Committee to Bridge the Gap Critique of the Work Plan for Retesting of Parcel G Hunters Point Naval Shipyard

15 August 2018

Attachment – CBG Detailed Comments on Parcel G Retesting Work Plan

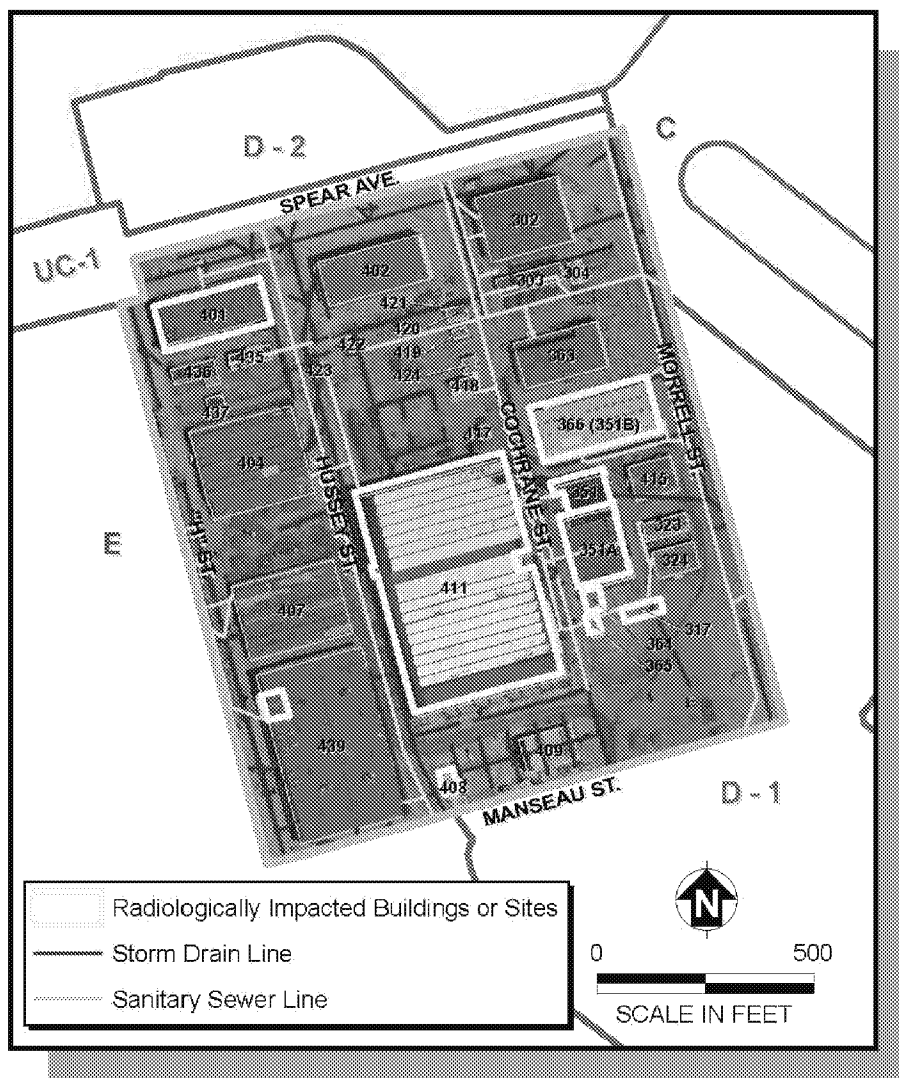
However, the Work Plan proposes just the opposite. Four of the five proposed locations for soil background measurements are right within Hunters Point itself; the fifth is nearby. All could be contaminated by the decades of releases, spills, and airborne deposition of contamination. Only

Here is a map of their four primary soil locations for background, all within the Hunters Point Superfund site, all potentially contaminated:

Figure 8. Radiologically Impacted Areas

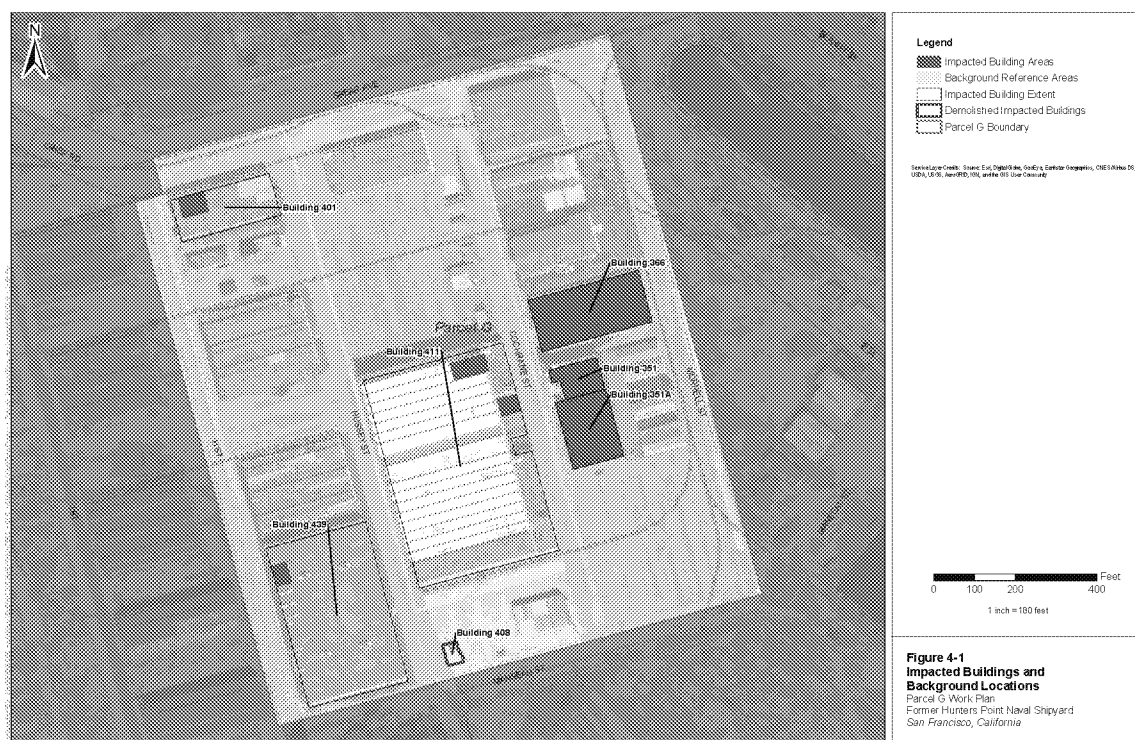
On the next page we have included a Navy figure showing which buildings in Parcel G it *admits* are radioactively impacted. You will see in particular in the upper lefthand corner Building 401, identified as radiologically impacted. Where does the Navy Work Plan propose taking its sole background measurements for buildings? Building 401. As you will see in the second graphic, it intends to take those measurements within an impacted building and a few feet from an area of the building it also concedes is impacted. This makes no sense – unless again one is trying to inflate background. Background measurements for buildings must be taken in buildings some distance from the Superfund site, not in its midst.
